DESCRIPTIVE REPORT

Registry No. H-10219

General Locality .. Bristol Bay

Sublocality Round Island & Vicinity

OPR-R184-RA-86
SHEET U
H-10219
1:20,000

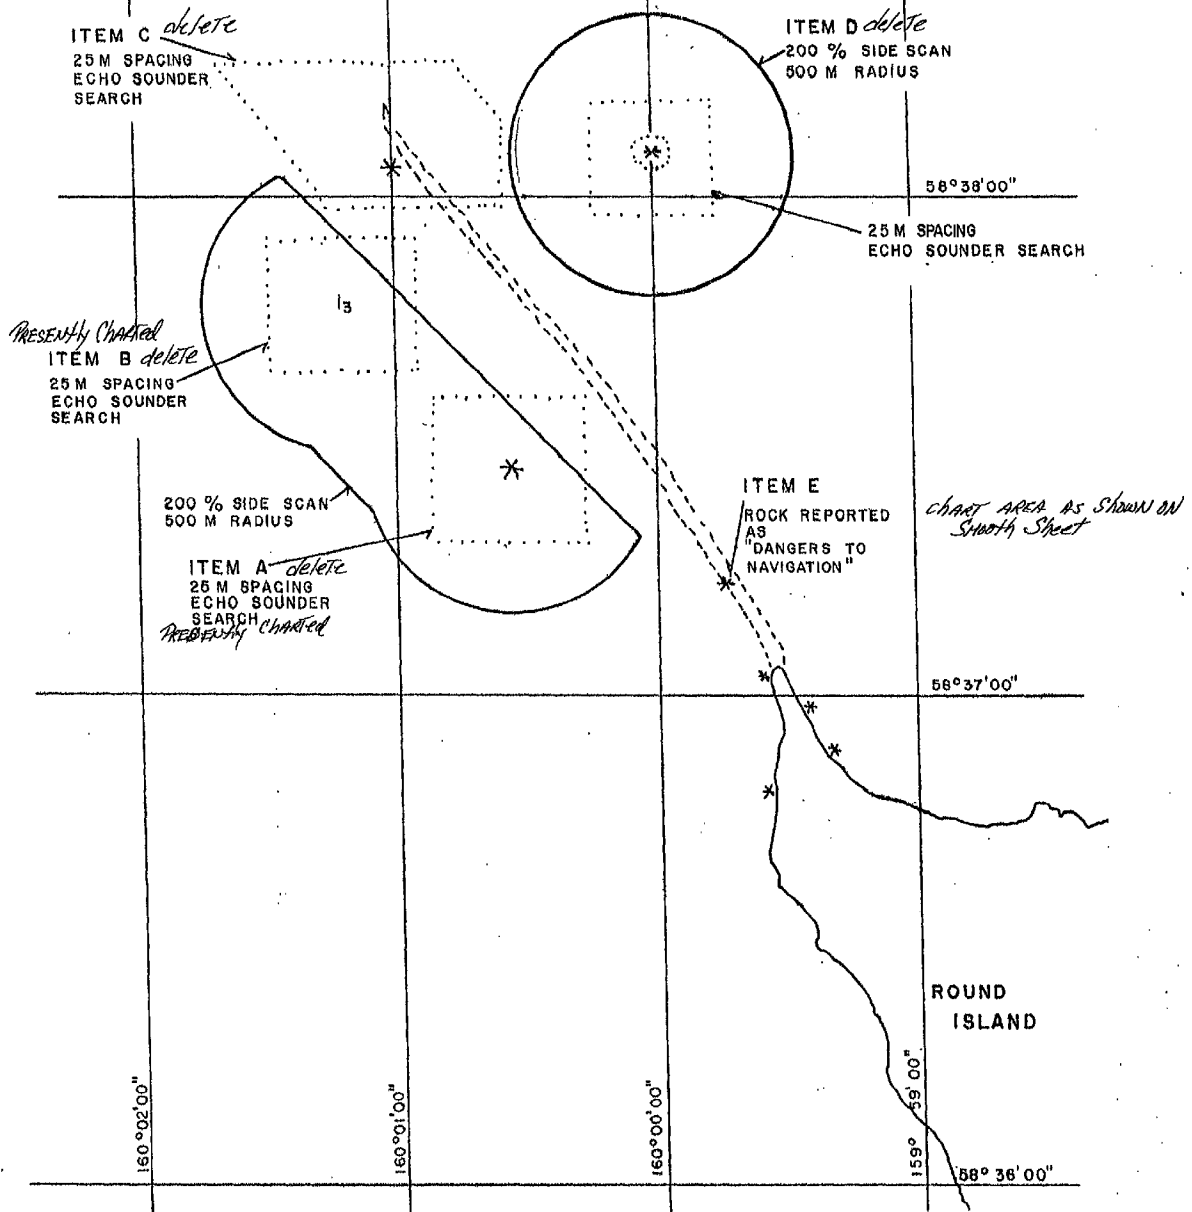
It is recommended that the manuscript rock in Item E be charted. *at Latitude 58°37'13.60"N Longitude 159°59'45.54"W* CHART AREA AS SHOWN ON SP1000th Sheet CONCUR

ATTACHMENT A

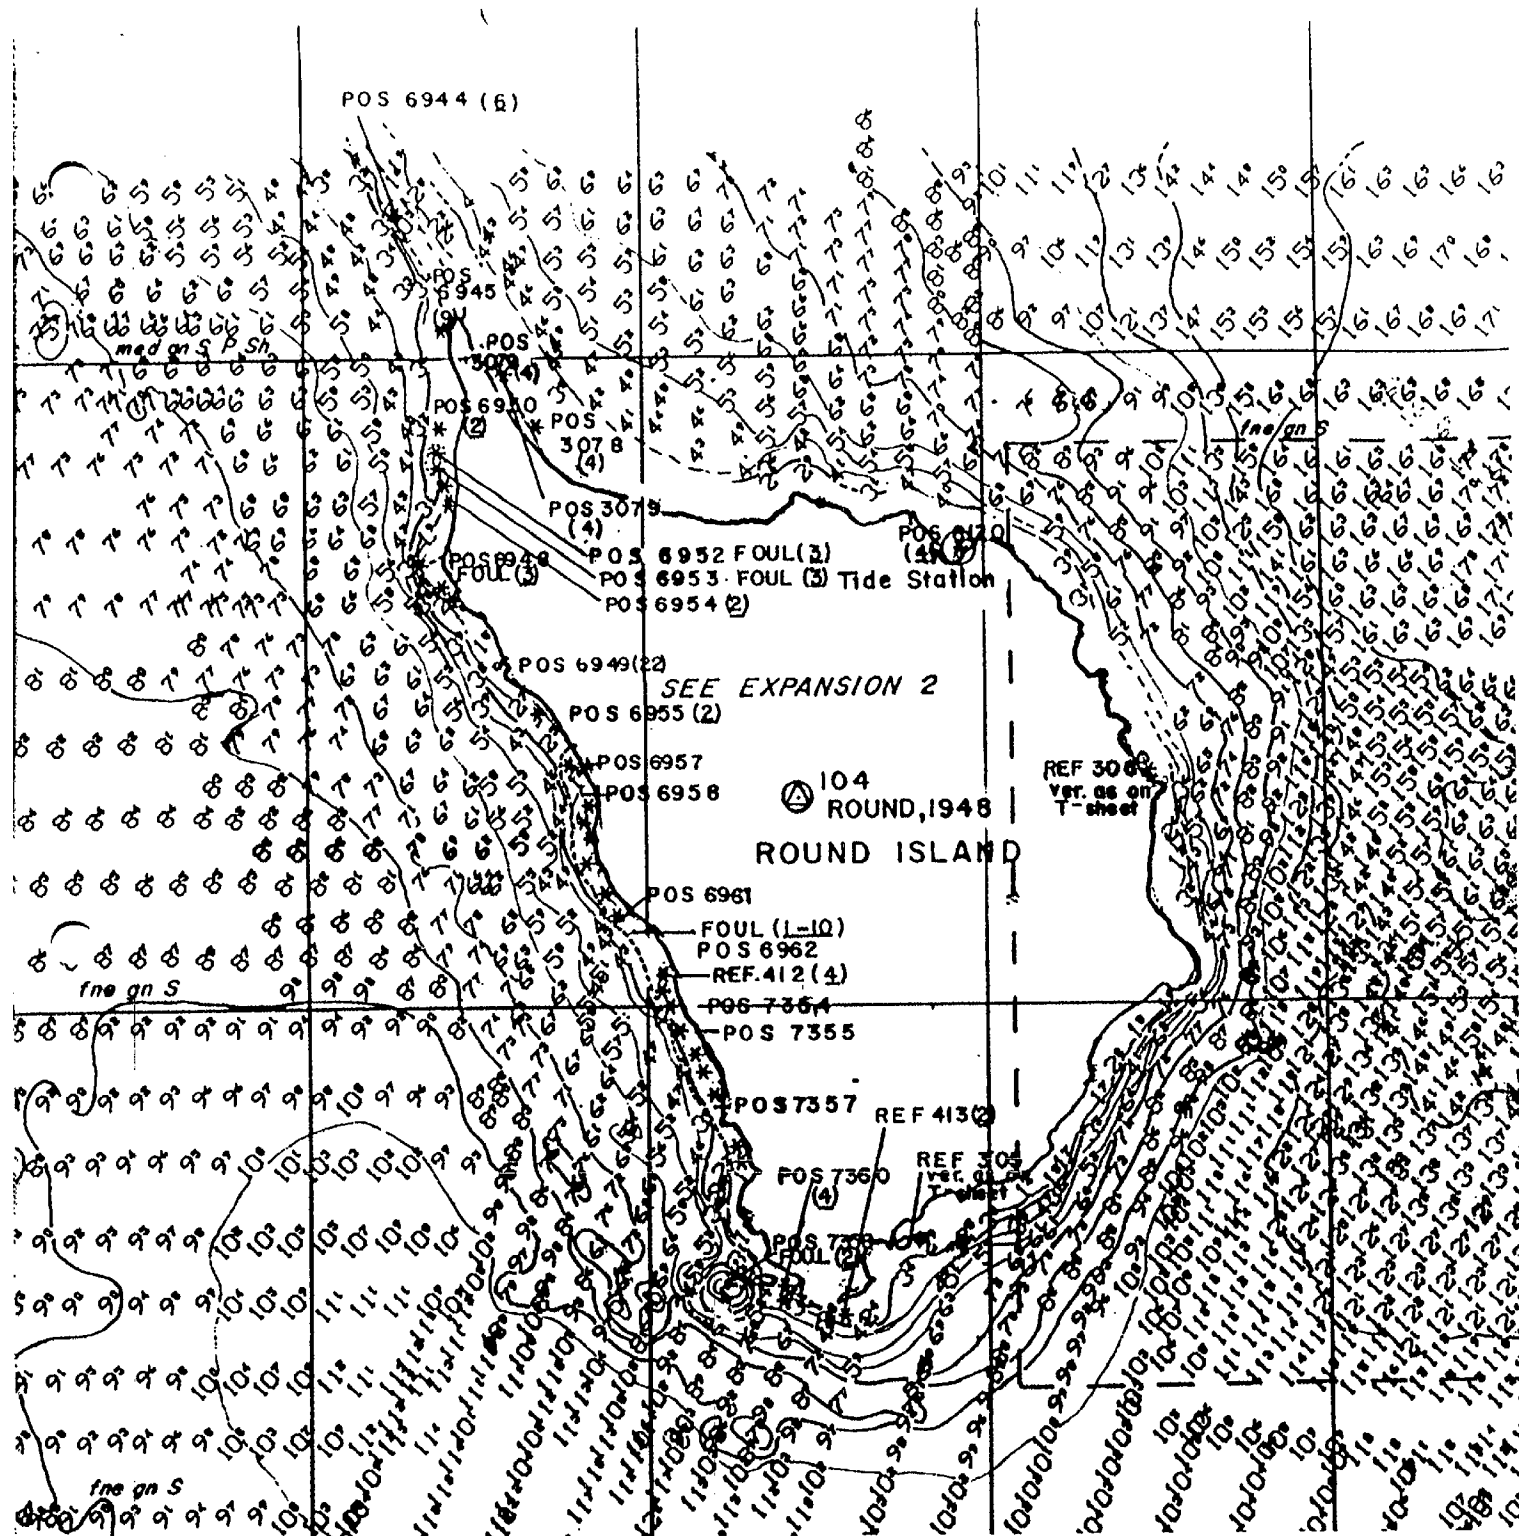
A number of rocks around Round Island were not identified by position number or reference number but the rocks were plotted on the final field sheet (attachment A). The Descriptive Report indicates shoreline verification on Round Island was extremely difficult due to the large population of Walrus which is protected by Alaska Fish and Wildlife Department Regulations. The survey records contain 21 reference-numbered observations which were apparently accomplished in the vicinity of Round Island, but only four of these observations were identified as features on the final field sheet. Each feature from the shoreline manuscript that is visually verified should be plotted on the final field sheet with associated reference number (PMC OPORTER Appendix P). It is not clear that all of the reference-numbered observations in the sounding volume represent shoreline manuscript features.

Rocks plotted on the final field sheet should be labeled with reference numbers for visual verification or position numbers when located. Several rocks on H-10219 have no such labeling.
